Prepared by Ellen Parker	Aircraft Make / Model Quest Kodiak	Float / Ski Model 7000 Amphibious floats	Page 1 2
-----------------------------	---------------------------------------	---	----------------

FAA Reviewed <input checked="" type="checkbox"/>	Title Kodiak Top Arm Modification, 7000 Main Gear
---	--

## SERVICE KIT: 76

TOP ARM MODIFICATION, 7000 MAIN GEAR

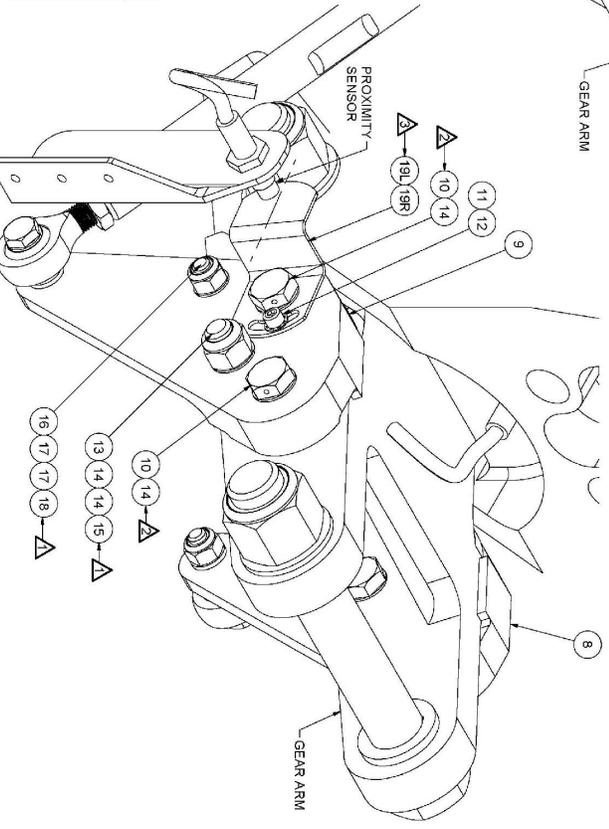
<b>EFFECTIVITY</b>	7000 Float Serial Numbers 70001-70026
<b>COMPLIANCE</b>	Mandatory compliance for effective serial numbers. Change will be added to manufacturing process after 70026.
<b>BACKGROUND</b>	Engineering enhancement.
<b>COMPLIANCE METHOD</b>	SK-76 consists of all the parts on the "New Design Parts List". These parts will be supplied by Wipaire to be installed as indicated on the included drawing. NOTE: Wipaire may elect to send a fully assembled service kit that also includes new gear arms. If a fully assembled kit is provided, the old unit can be unbolted by removing the two AN10 bolts, one at the main pivot location, one at the top of the shock strut and the two AN4 bolts at the attaching rod-ends. The sensor flags must be checked for correct positioning after installation of the new components and adjusted per the service manual. Please send the removed parts back to Wipaire for inspection.

- NOTES:
- ▲ MATCH DRILL ARM BRACKET HOLES INTO GEAR ARM
  - ▲ SAFETY WIRE
  - ▲ ALIGN CENTER OF FLAG WITH PROXIMITY SENSOR & ENSURE THAT THE FLAG DOES NOT HIT AND BREAK THE PROXIMITY SWITCH ON GEAR CHECK & SUBSEQUENT SWITCH LIGHT ADJUSTMENT.

OLD DESIGN  
LEFT GEAR SHOWN - RIGHT OPPOSITE  
SCALE 1 : 1

NEW DESIGN  
LEFT GEAR SHOWN - RIGHT OPPOSITE  
SCALE 1 : 1
